- **DR07-14
Sanctuary on Higley
Higley Road and Enid Ave.
attn.: John Wesley, Planning Director**

- **Letter of Explanation:**

Date: August 10, 2016
To: Fred Woods, Architect
From: Charlotte Bridges, Planner I
Subject: PLN2016-03056 -- Administrative Review Request to modify the site wall design and paint palette for the Sanctuary on Higley townhomes, 5225 E. Enid St.
RE: First Review Comments

CASE #: DR07-14 **Sanctuary on Higley**
LOCATION/ADDRESS: SEC Enid & Higley
REQUEST: Approval of a 26 lot townhome project
COUNCIL DISTRICT: District 6
OWNER: RSB Partners
APPLICANT: Woods Associates
ARCHITECT: Fred Woods

FORGE AVENUE PEDESTRIAN GATE

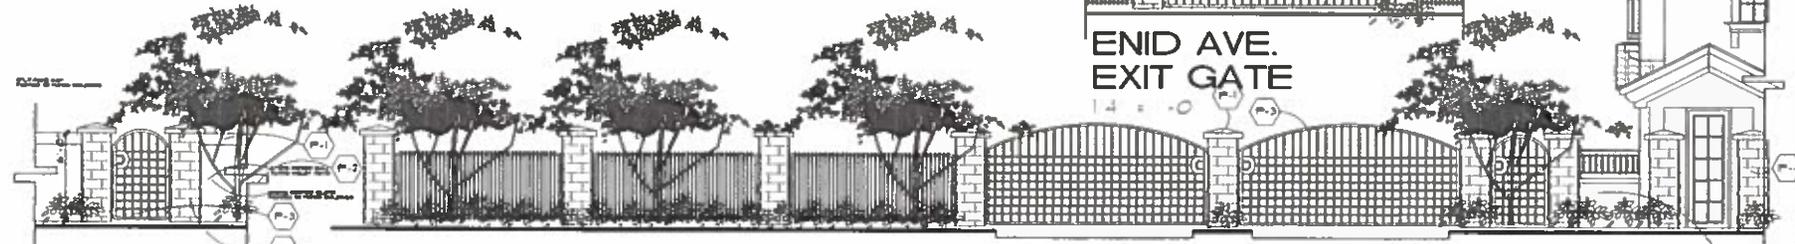
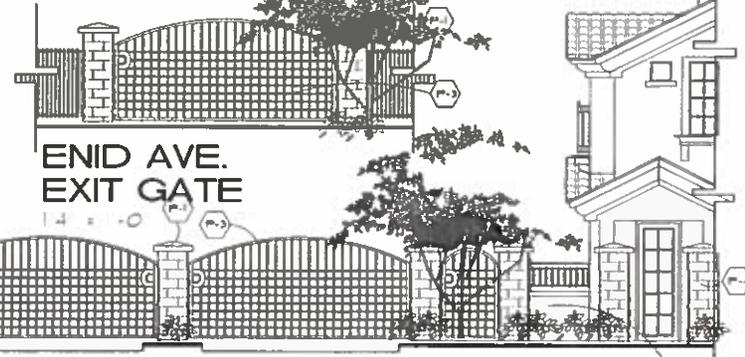
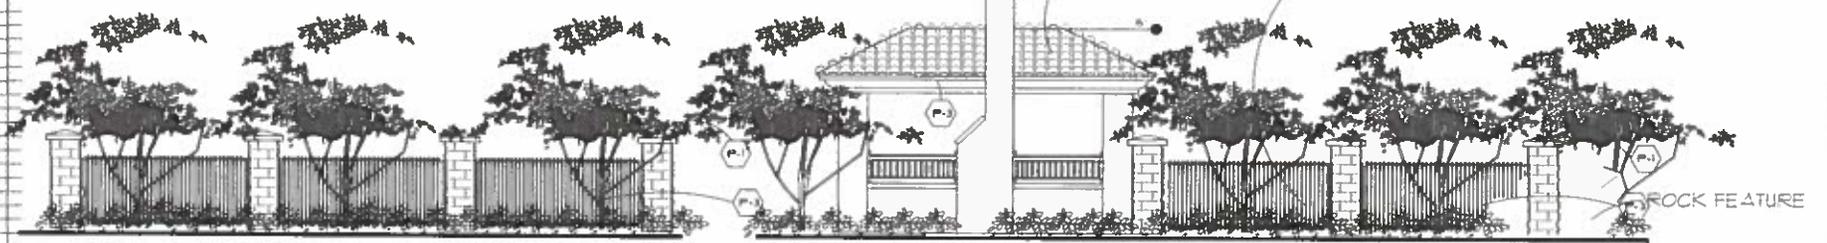
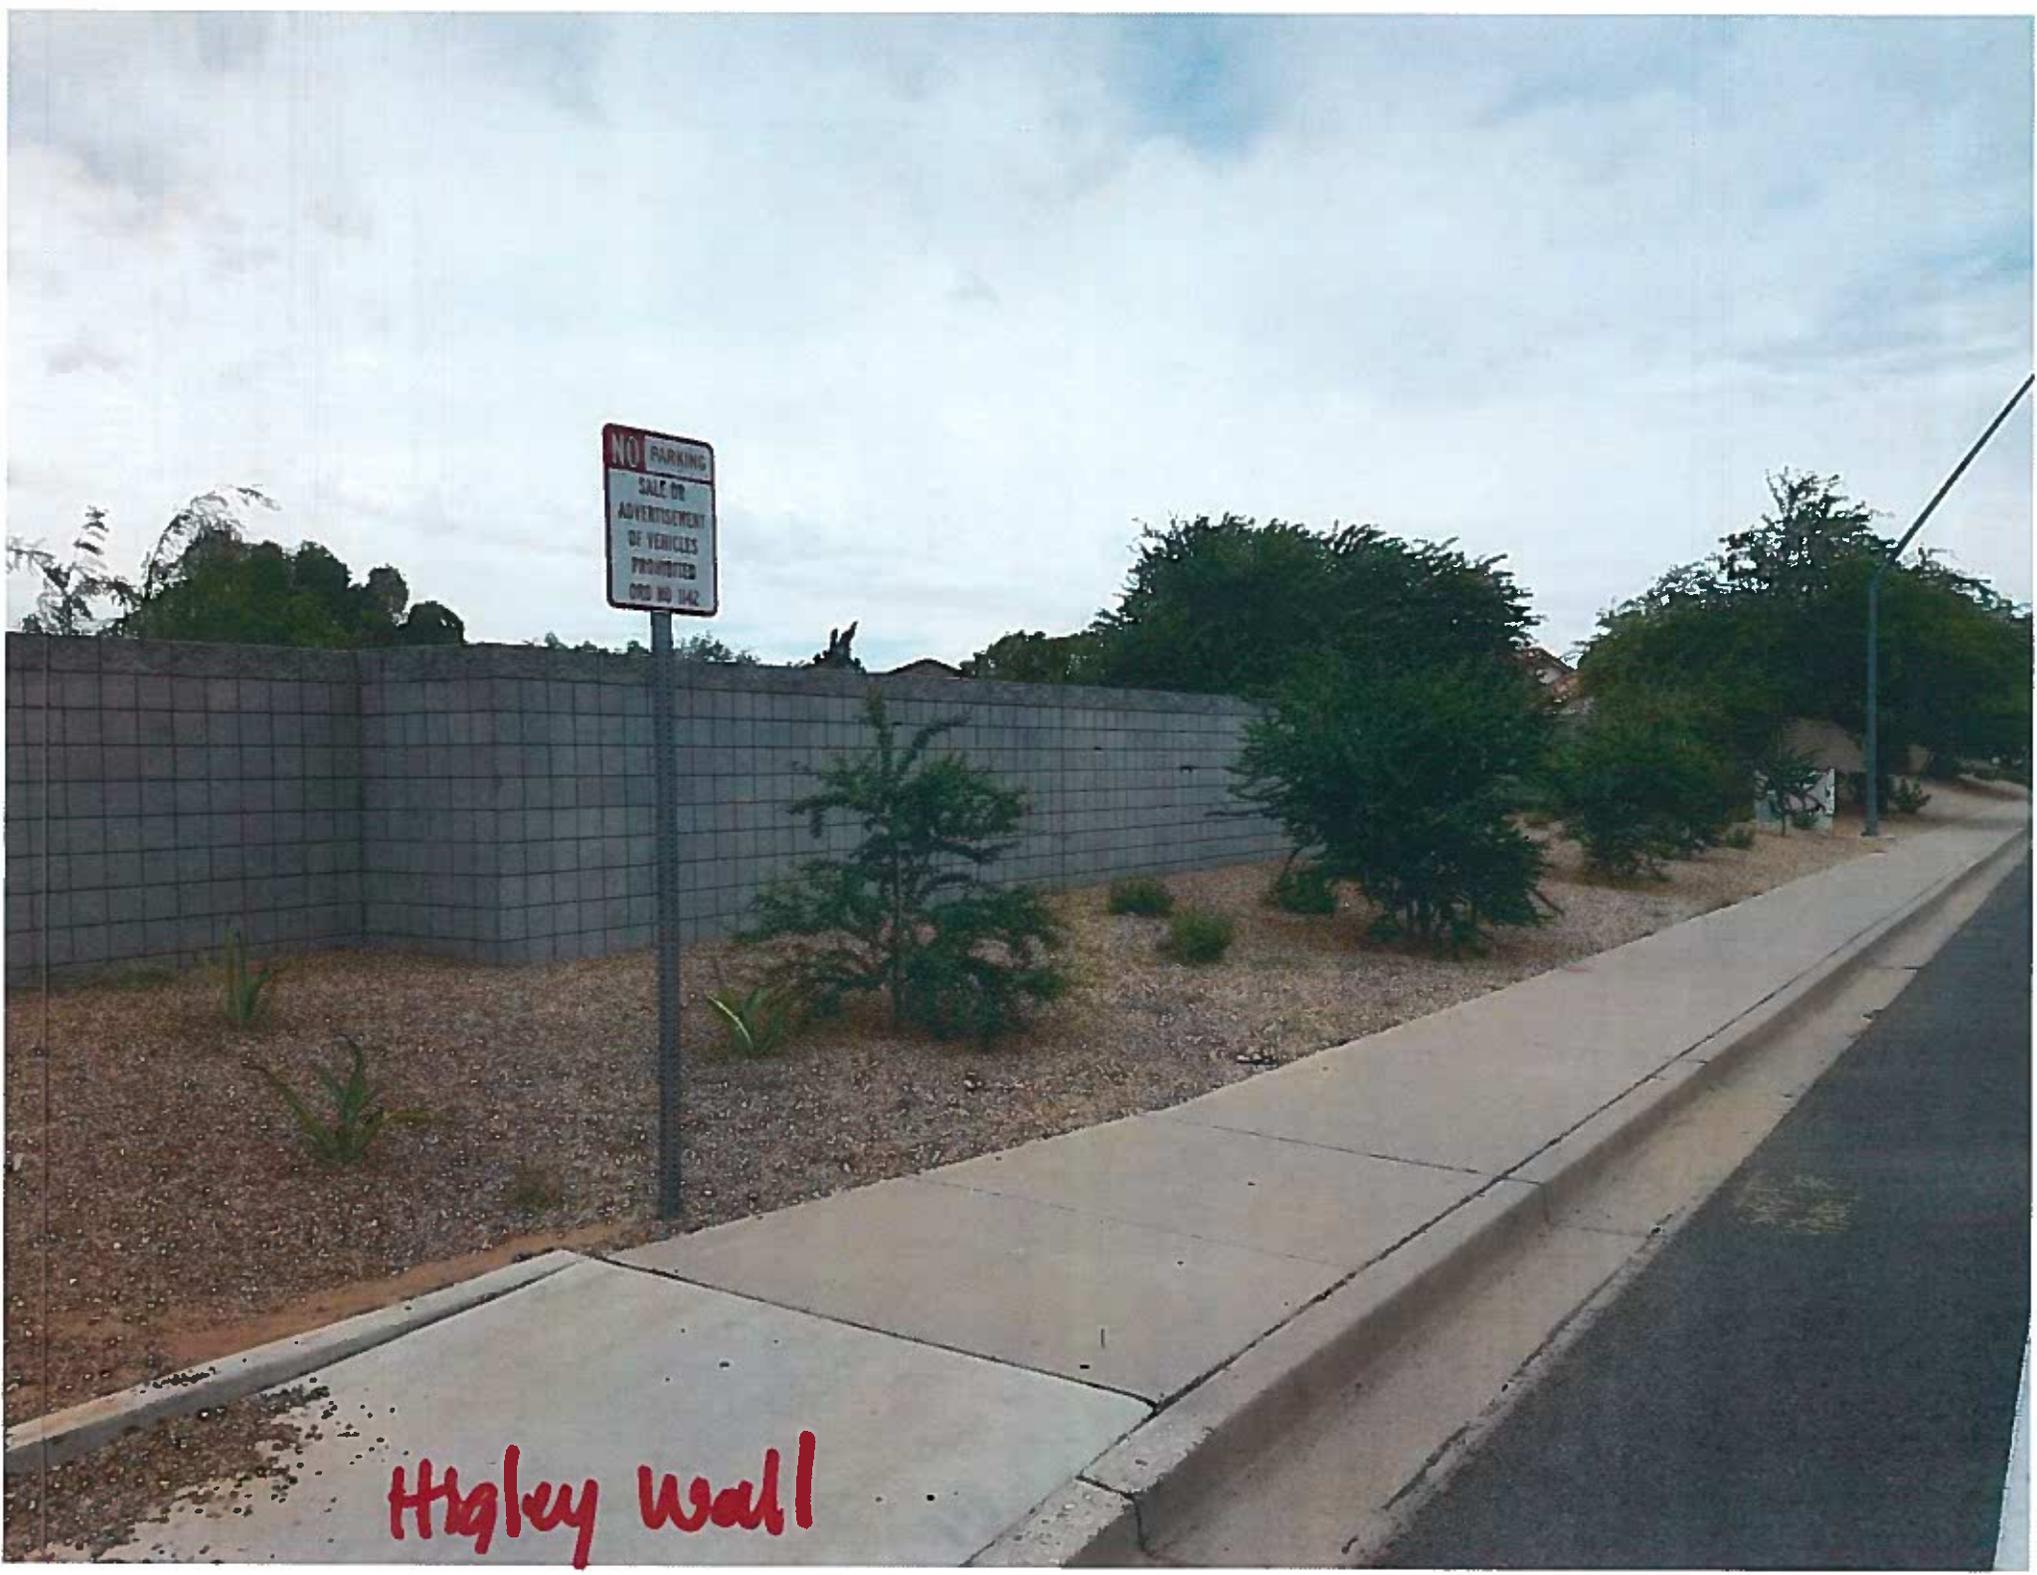
The developer is requesting Administrative Design Review approval of the following minor changes to the approved Design Review Case # DR07-14:

1. Change the cultured stone which was approved for the site wall fence bollards to split face block painted 'Mesa Tan' from the approved DR07-14 color pallet.
2. Change the color of the building fascia trim from the approved color "Tickled Crow" (green) to "Mesa Tan" from the approved DR07-14 color pallet.

1. The proposed change to the paint palette for the project is acceptable. Provide an 8-1/2" X 11" FLAT color sheet with **actual paint chips** and brochure or accurate color reproductions of the proposed building materials, cross-referenced to the material legend/finish schedule on the elevations. Color sheet must identify manufacturer and color/material name.
2. Provide a set of 11" X 17" revised color building elevations cross-referenced to the revised color sheet paint palette.
3. Planning staff does not support the request to remove the cultured stone veneer from the site wall fence bollards and replace the design with split face block painted "Mesa Tan" since the proposed replacement design is "not equal to or better than the quality of material" originally approved by the Design Review Board. Revise the proposed design of the bollards to meet the above noted design criteria.

FORGE AVENUE PEDESTRIAN GATE

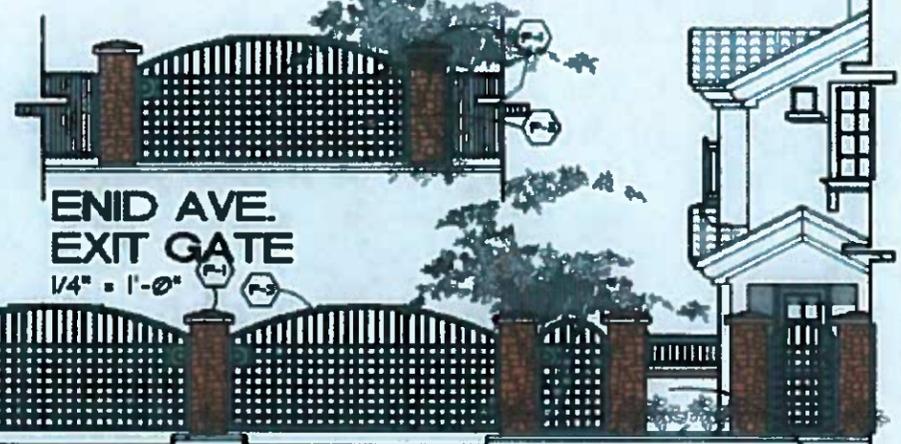
- a. Provide exterior light fixture cut sheets. Details to be reviewed and approved by Design Review staff.
 - b. Provide a building elevation with the patio walls. Details to be reviewed and approved by Design Review staff. Wall design to be as shown in the partial elevation "Forge Avenue Pedestrian Gate" on Sheet A-0 2.

- The outlines of the patio walls are lightly ghosted-in on the proposed building elevations. Staff is recommending a condition of approval that requires the applicant to provide an elevation of the patio walls. The wall design should be as shown in the partial elevation "Forge Avenue Pedestrian Gate" on Sheet A-0 2. (See condition 1b)
- No colored ramada elevation was provided. (See condition 1c)
